## REVISED RESPONSE TO REQUEST FOR ADDITIONAL INFORMATION

### APR1400 Design Certification

RAI No.: 475-8596  
SRP Section: 10.04.08 – Steam Generator Blowdown System  
Application Section: 10.4.8  
Date of RAI Issue: 05/04/2016

### **Question No. 10.04.08-6**

Figure 2.7.1.8-1 Steam Generator Blowdown System

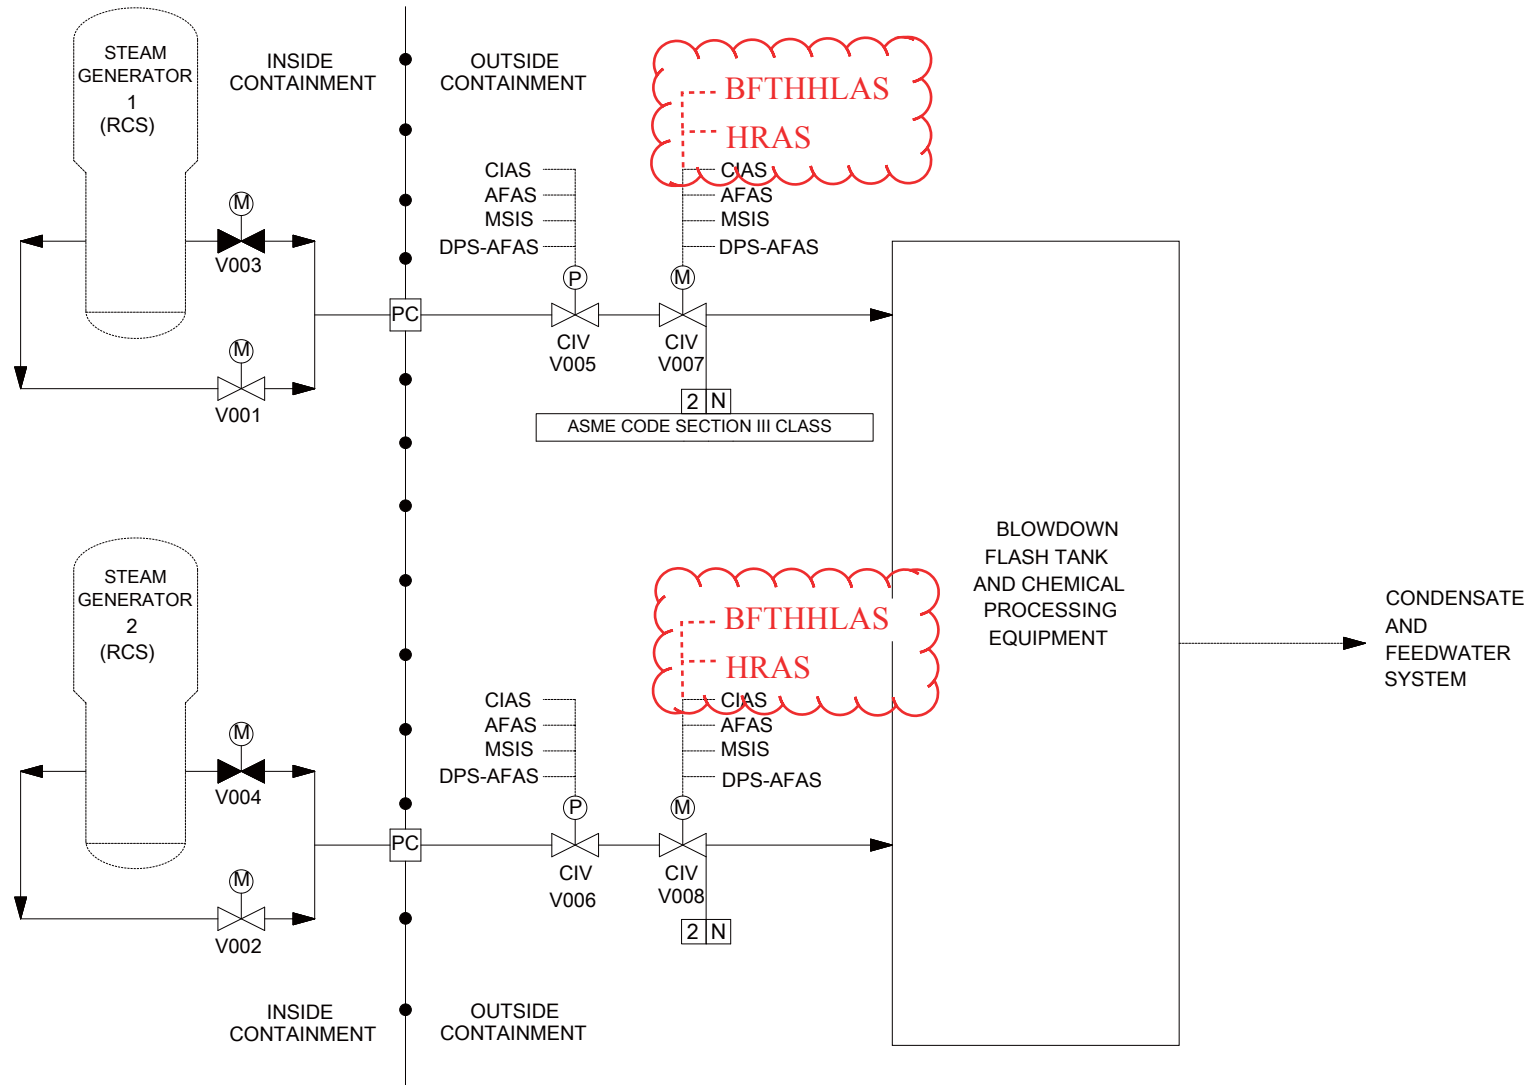
- a. The response proposes listing additional control signals in Tier 1 Table 2.7.1.8-1, but there is no corresponding change proposed for Tier 1 Figure 2.7.1.8-1. Since Figure 2.7.1.8-1 shows the control signals associated with containment isolation valves, provide your plans for revising Figure 2.7.1.8-1 or the basis for not revising it.
- b. The response indicates that Tier 2 Chapter 7 intentionally discusses the instrumentation and controls at a higher level and does not describe individual signals. The staff determined that for consistency and clarity, the signals that activate the containment isolation valves should be identified in Chapter 7, especially in the functional diagrams. Please discuss your plans to add this information to the FSAR.

- a. DCD Tier 1 Figure 2.7.1.8-1 and ACRONYM AND ABBREVIATION LIST will be revised to include the HRAS and the BFTHHLAS signals as indicated in the Attachment. And the signal lines in DCD Tier 2 Figure 10.4.8-1 will be revised to a dashed line as indicated in the Attachment.
- b. To activate the containment isolation valves (CIVs), following signals are used:
  1. ESFAS (e.g., SIAS, CSAS, CIAS, MSIS, and AFAS) and DPS (e.g., DPS-AFAS) signals

For example, steam generator blowdown system CIVs 005, 006, 007, and 008 in Figure 2.7.1.8-1 of DCD Tier 1 are actuated by the CIAS, AFAS, MSIS, and DPS-SIAS. However, those CIVs are not related with the SIAS and CSAS.
